STAFF RECOMMENDATION
2306 White Avenue
June 16, 2021

Metropolitan Historic Zoning Commission
Sunnyside in Sevier Park
3000 Granny White Pike
Nashville, Tennessee 37204
Telephone: (615) 862-7970
Fax: (615) 862-7974

Application: New Construction—Addition; Partial Demolition
District: Woodland in Waverly Historic Preservation Zoning Overlay
Council District: 17
Base Zoning: R6
Map and Parcel Number: 10514022900
Applicant: Daniel Hayes
Project Lead: Melissa Sajid, melissa.sajid@nashville.gov

1 Architectural Site Plan
SCALE: 1/32" = 1'-0"

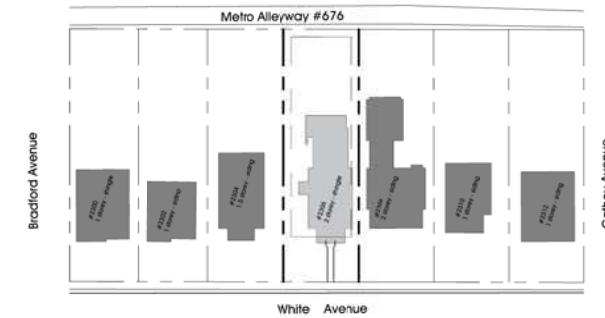
1. CONTRACTOR IS TO HAVE HISTORIC COMMISSION STAFF REVIEW THE CONDITION OF THE HISTORIC WOOD SIDING ONCE THE NON HISTORIC SIDING HAS BEEN REMOVED TO ASSESS IF ANY PART NEEDS TO BE REPLACED.

2. CONTRACTOR IS TO NOTE THAT ONLY THE WINDOW SASHES BE REMOVED WHERE WINDOWS ARE TO BE REPLACED ON THE SIDE FACADES. IN ORDER TO PRESERVE THE WINDOW FRAMES.

3. HISTORIC COMMISSION IS TO APPROVE ALL NEW WINDOW AND DOOR SPECIFICATIONS PRIOR TO ORDERING AND INSTALLATION.
4. HISTORIC COMMISSION STAFF IS TO APPROVE THE ROOF SHINGLE MATERIAL, COLOR, AND TEXTURE PRIOR TO ORDERING AND INSTALLATION.

5. HISTORIC COMMISSION STAFF IS TO APPROVE BRICK SAMPLES BEFORE ORDERING AND INSTALLATION.
6. IT SHALL BE NOTED THAT THE HISTORIC COMMISSION HAS APPROVED THE CMU BLOCK FOR THE FOUNDATION TO BE SPLIT FACE CONCRETE BLOCK - CONTRACTOR IS TO COORDINATE CMU SELECTION WITH ARCHITECT.

7. ALL PORCH COLUMNS ARE TO HAVE A CAP AND BASE THAT IS CONSISTENT WITH THE CHARACTER AND APPEARANCE OF THE EXISTING.
8. CONTRACTOR IS TO NOTE THAT EXTERIOR HVAC UNITS BE LOCATED BEHIND THE HOUSE OR ON EITHER SIDE, BEYOND THE MID-POINT OF THE HOUSE.

9. HISTORIC COMMISSION STAFF IS TO APPROVE ANY PERMANENT LANDSCAPE FEATURES, INCLUDING, BUT NOT LIMITED TO: FENCES, PARKING PADS, AND WALKWAYS.

1 Roof Plan
SCALE: 1/8" = 1'-0"

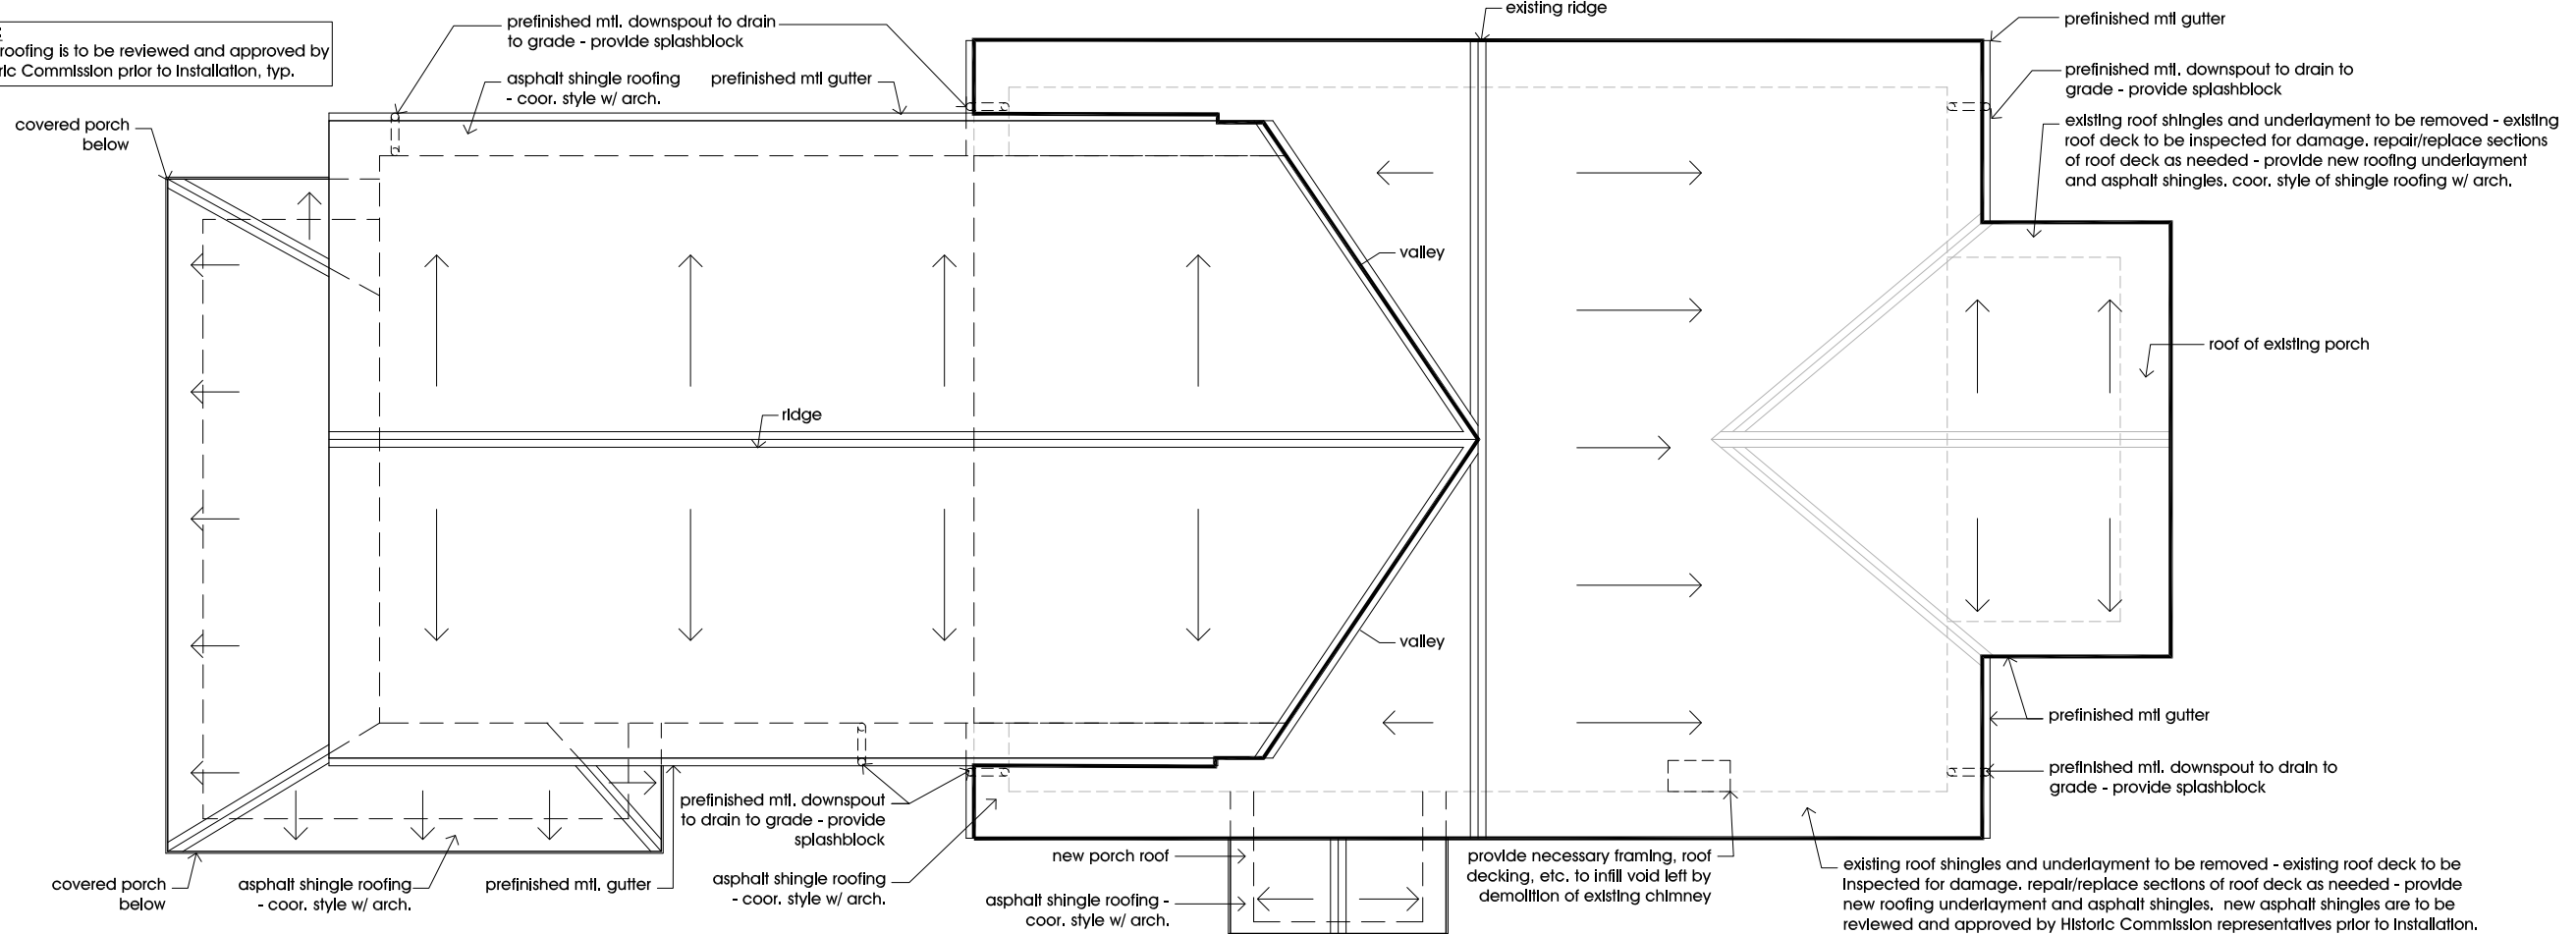
note:
new roofing is to be reviewed and approved by
Historic Commission prior to installation, typ.

1 West Exterior Elevation
SCALE: 1/8" = 1'-0"

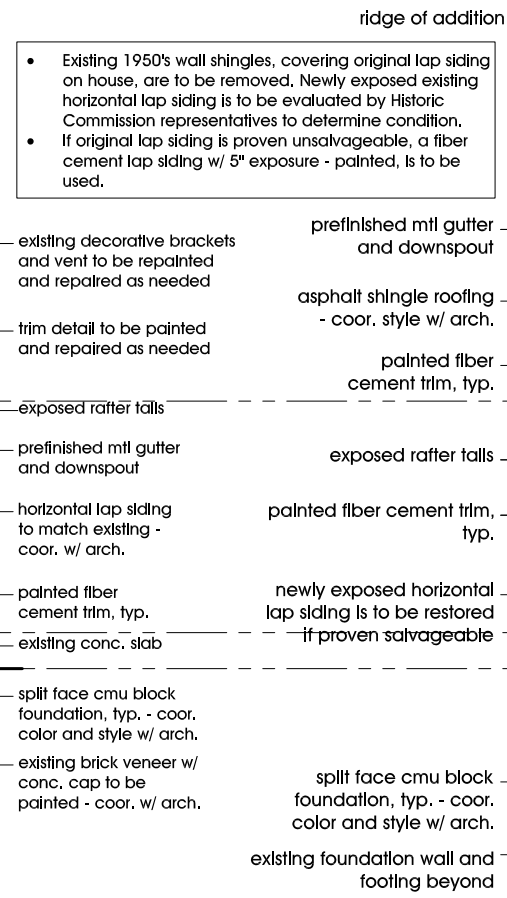
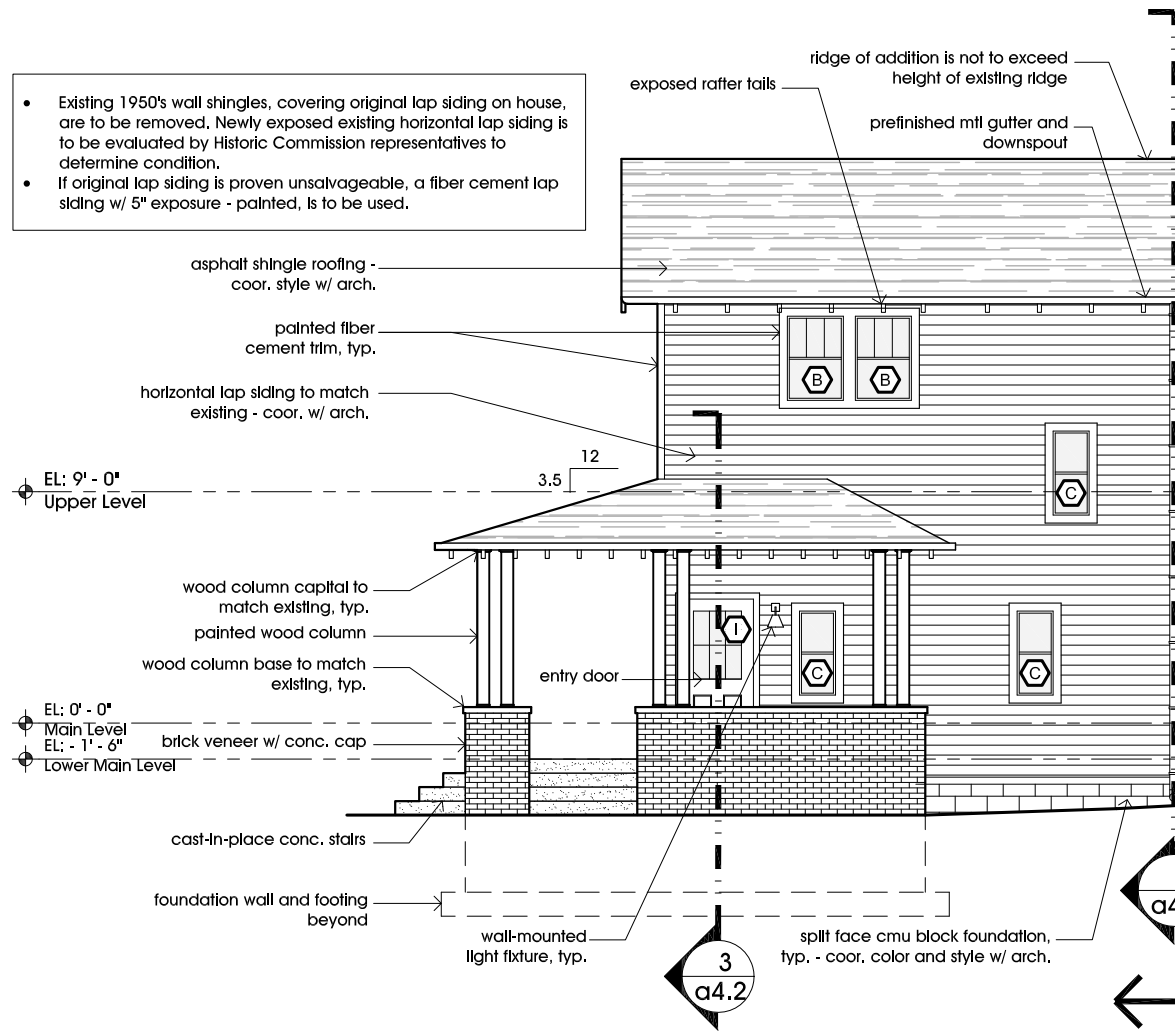
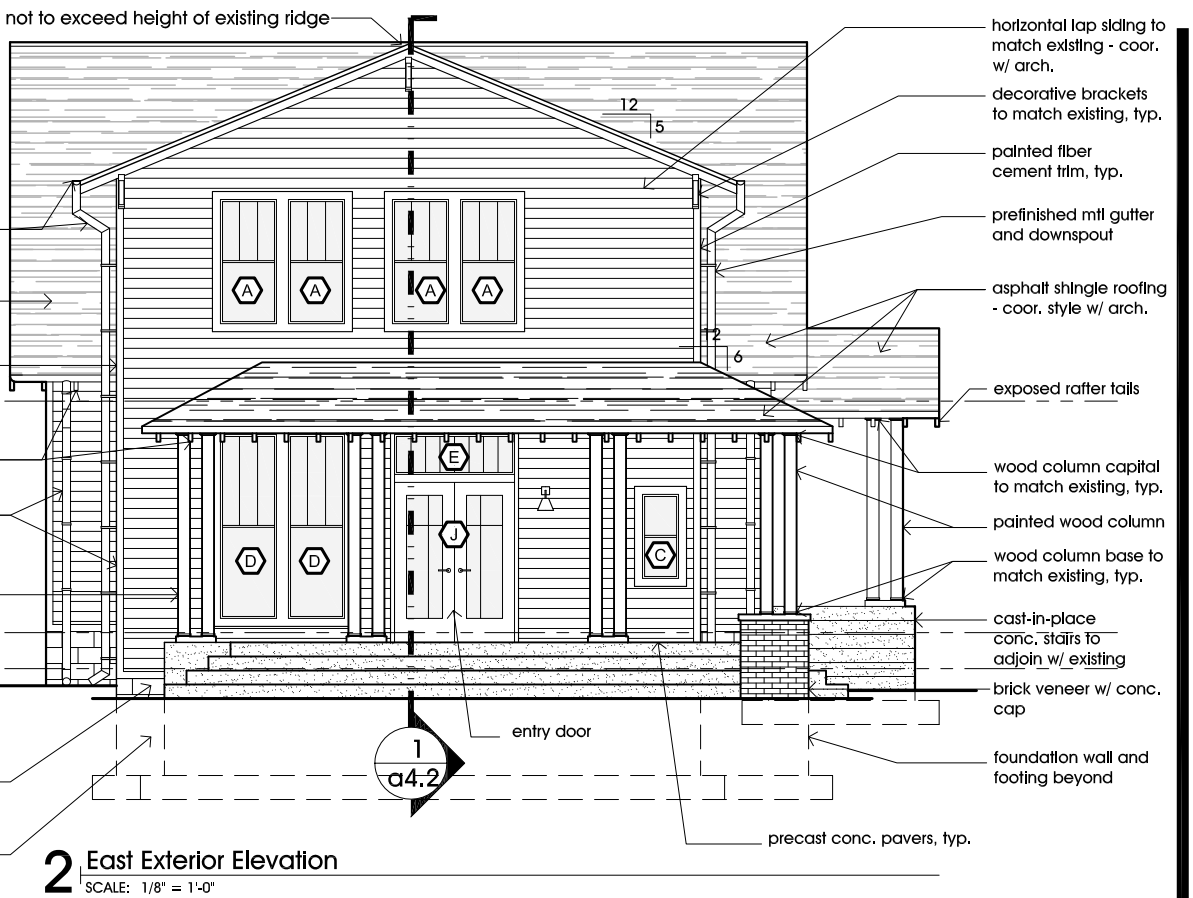
The eave height of the addition is approximately nine feet (9’) taller than the historic house’s eaves. While the Commission found that this two-story form could be appropriate in 2016, the current Commission’s interpretation of the guidelines has incorporated the neighborhoods’ concerns about the increasing scale of proposed additions and found that two story additions to one or one and one-half story homes may not be the best fit for the guidelines. For this reason, staff recommends that the eave height of the addition be reduced to be similar in height to the eaves of the historic house. Living space in an upper-level can be achieved with a cross-gable roof form or appropriately scaled dormers that meet the guidelines. Appropriately sized dormers

With the condition that the eave height be reduced to be similar to the eave height of the historic house, staff finds that the addition's height and scale can meet Section III.B.1., III.B.2.a., and III.B.2.b. of the design guidelines.

Design, Location and Removability: The addition is located behind the historic house and is inset two feet (2') from its sidewalls for the full depth of the addition. The addition is designed so that if it were to be removed in the future, the historic house's primary form would remain. While the addition's inset, materials, and proportion and rhythm of openings are compatible with the historic character of the existing house, the scale of the addition is not compatible as it is a two-story addition to a one and one-half story house. The proposed eaves and wall height of the addition overwhelm the scale of the historic house.

1. The eave height of the addition shall be reduced to be similar to the eave height on the historic house;
2. Only the window sashes be removed where windows are to be replaced on the side facades, in order to preserve the window frames;
3. Staff approve all final selections for the roof color, windows, and doors prior to purchase and installation;
4. Staff approve a brick sample;
5. Staff approve any permanent landscape features, including, but not limited to, fences, parking pads, and walkways; and
6. The trim and posts of the previously approved side porch be painted.
